SCIENTIA PROJECT - MONTE SANT ANGELO MERCY COLLEGE (SSD- 10393)

**RESPONSE TO
SUBMISSIONS**

18 August 2020

Figure 18 Updated Landscape Plan

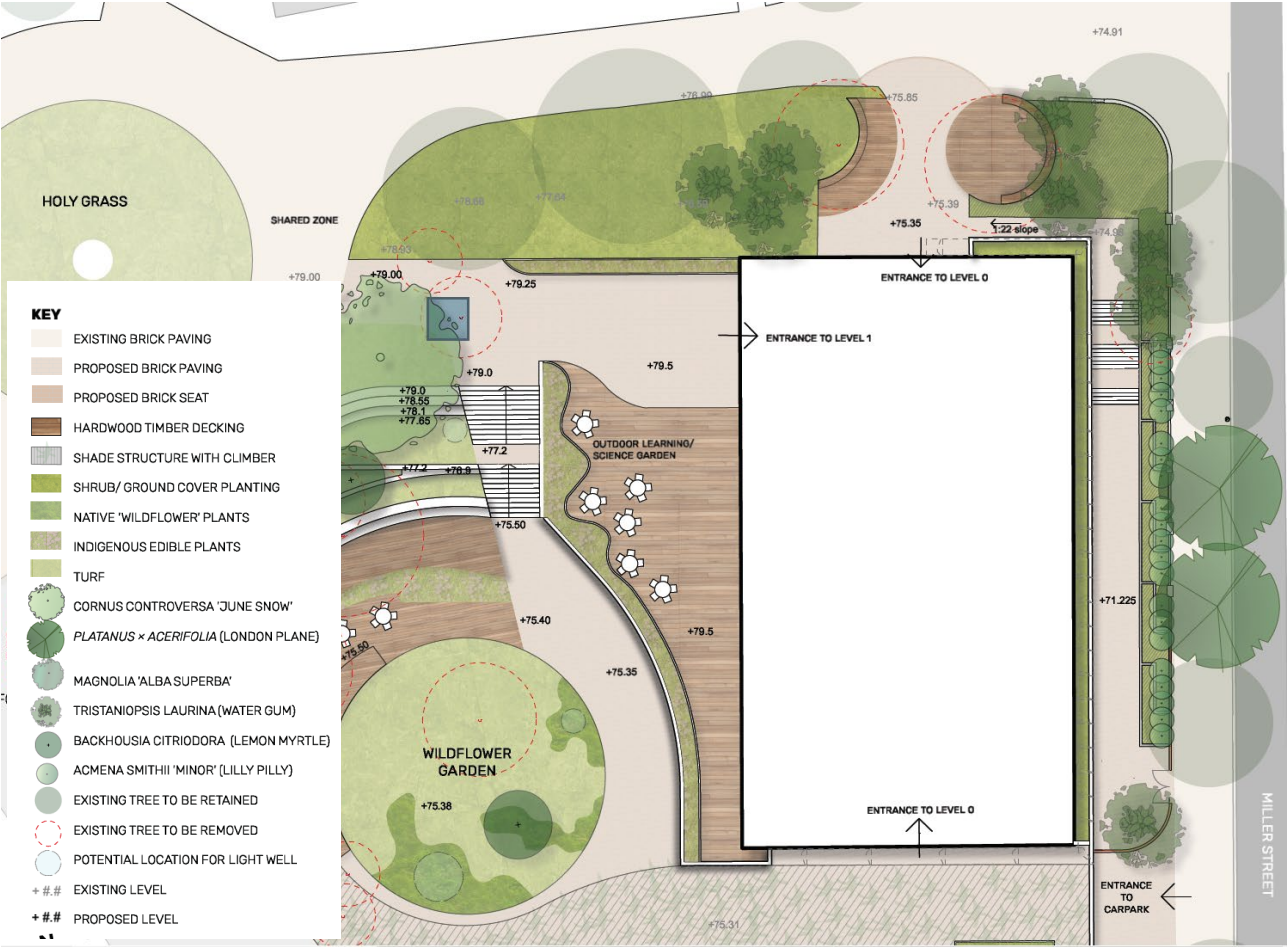
Submission	Comments/Report Reference
	the new building and continue the existing landscape character along Miller Street (to be coordinated with North Sydney Council and Arborist). Revised Landscape Plans are attached at Appendix C. Tree protection zone is discussed in Section 4.3. As discussed above and confirmed by the Arboricultural Impact Assessment, the following trees are been retained and protected: ▪ High retention value: – Araucaria cunninghamii (Hoop Pine) - Tree 6 – Araucaria heterophylla (Norfolk Island Pine) - Tree 11 – Syzygium sp. (Lilli Pilli) - Tree 10 ▪ Medium retention value: – Lophostemon confertus (Brush Box) - Tree 9 These trees are also indicated on the Landscape Plan (see Appendix C). In accordance with the assessment provided within the Arboricultural Impact Assessment, Trees 6, 9, 10 and 11 are subject to moderate levels of encroachment (10-20%) of the TPZ. Three of the four trees have minor encroachment of less than 10%, tree pruning measures and TPZ has been established to protect these trees. Tree 11 has an enforcement of 20%, however there had been much previous disturbance from earlier works and the soil in this area is predominantly fill. Given the tree roots are less than 10mm, excavation is to be completed without benching or over-excavation i.e. contiguous piling, sheet piling or similar. The specific approach needs to be addressed in the final Construction

A summary of trees removed, retained and proposed is outlined below (refer to Figure 18):

Furthermore, the loss of trees is proposed to be offset by the planting of 38 trees throughout the site area and along Miller Street (including street trees). The location of these new trees has been selected to allow for maximum sunlight and assist with plant growth.

Figure 24 Location plan of nearby construction activity

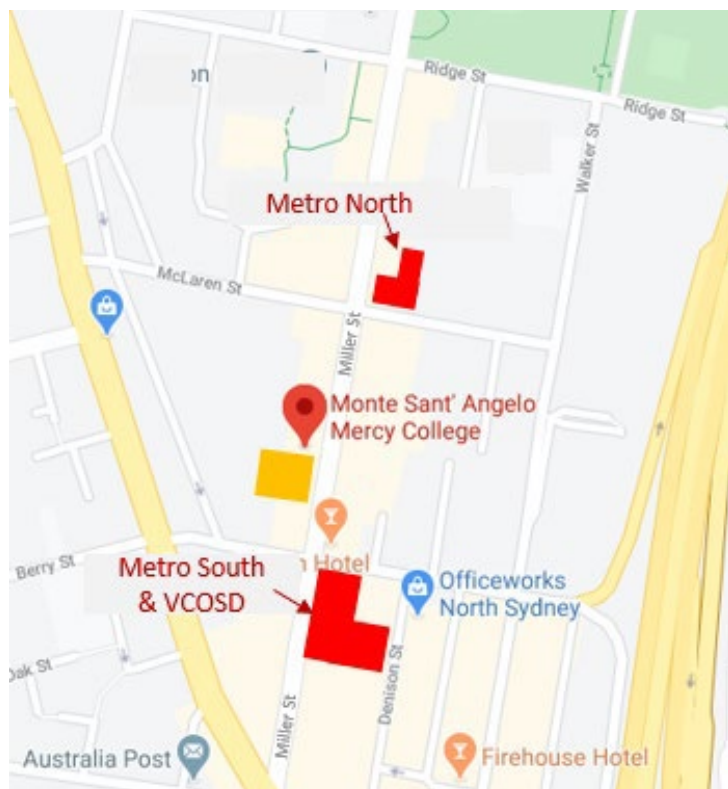
Submission	Comments/Report Reference
Public Submissions – key issues	
Cumulative construction traffic and noise impact.	Additional accumulative traffic and noise impact are discussed in Section 8. An updated Construction Traffic Management Plan is attached at Appendix G. Cumulative construction noise impact has been assessed by Wilkson Murray and included in Appendix F.
Request construction to start at the beginning of next year in order to respect social distancing and nearby residents working from home. Construction hour is restricted to 5pm Monday to Friday and no weekend work.	In relation to community's concern on construction hour and COVID social distancing restriction, the College will comply with conditions placed by DPIE with regards to allowed construction hours, and government regulation on relevant COVID-19 construction and health advice and notes the gradual restoration of working practices. The proposed construction hours are consistent with the recommended standard hours of work by the NSW Interim Construction Noise Guideline. Timely construction of the project will reduce the period of construction, to allow students to benefit from the prompt commencement and efficient completion and delivery of the project.

Concurrent construction works from nearby sites includes the following (refer to **Figure 24**):

Figure 25 Scientia and Victoria Cross North & South Sites – Haulage Routes

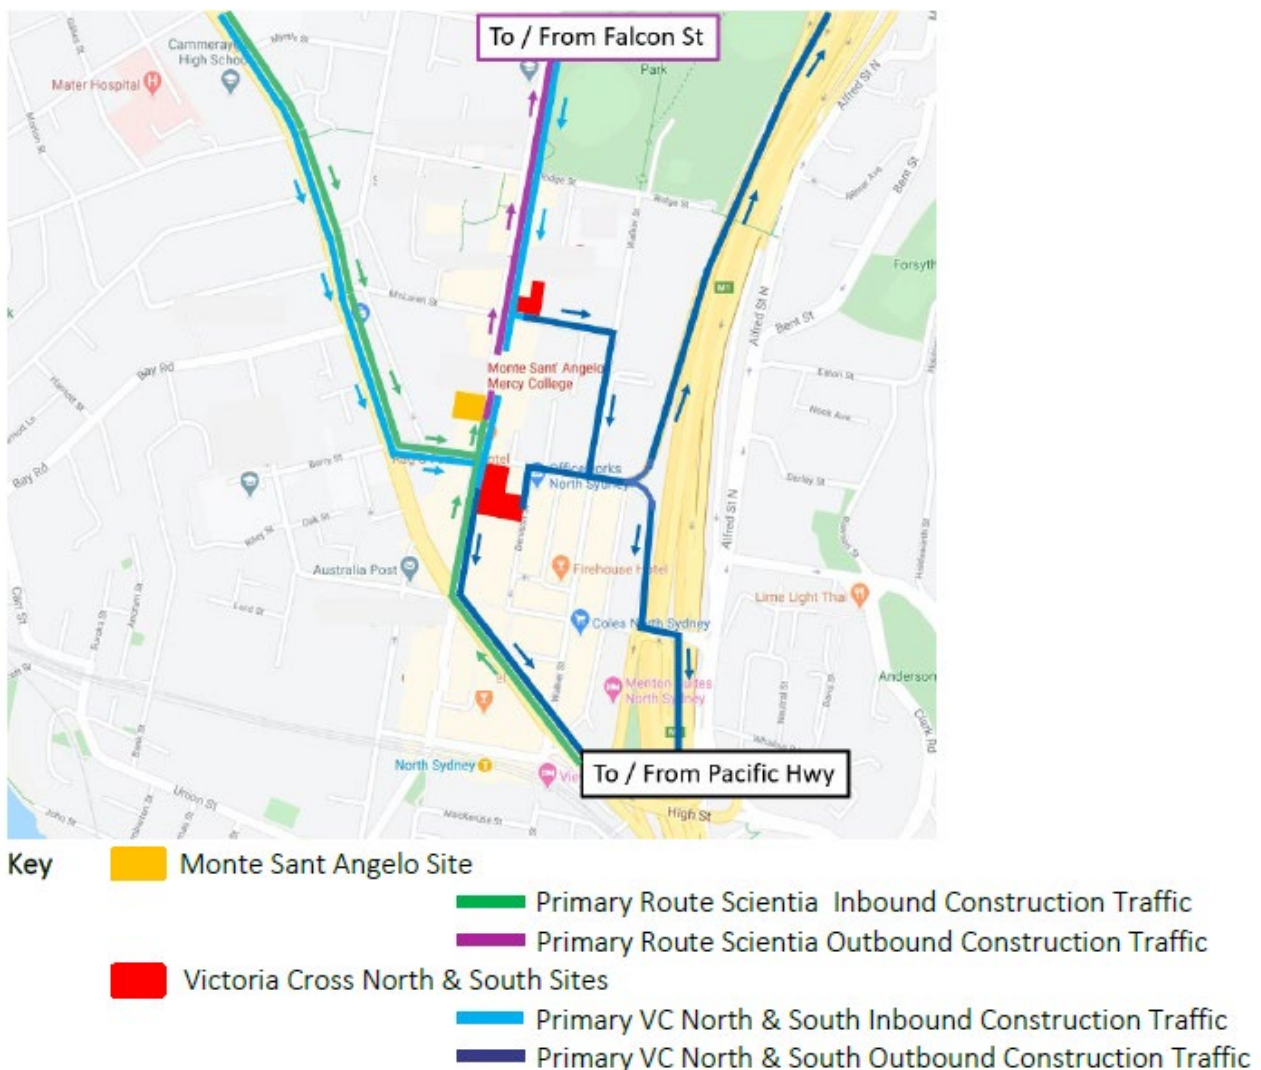
Submission	Comments/Report Reference
Conversely the proposed development is not likely to impact Western Harbour Tunnel and Beaches Link motorway projects. The applicant should be advised of the above and made necessary consideration on the planning of its construction activities in this regards.	
<u>Sydney Metro City and Southwest</u> The applicant and the proposal should consider construction activities of the Chatswood to Sydenham section of the Sydney Metro City and Southwest corridor.	Cumulative construction traffic impact has been assessed by Cornerstone and included in Appendix 4 of the Construction Traffic Management Plan (attached at Appendix G). Concurrent construction works from nearby sites includes the following: ▪ The Sydney Metro City and Southwest projects, which occupies two nearby sites. Victoria Cross Station South is located on the south east corner of Berry Street and Miller Street. Victoria Cross Station North is located at the corner of McLaren Street and Miller Street. ▪ The Victoria Cross South Over Station Development (VCOSD). Cumulative construction traffic impact is discussed in Section 8.3.1.

Victoria Cross Station South and North are currently under construction. **Figure 25** below overlays the haulage routes of the Victoria Cross Station projects (North and South) and the proposed haulage routes of the Scientia project:
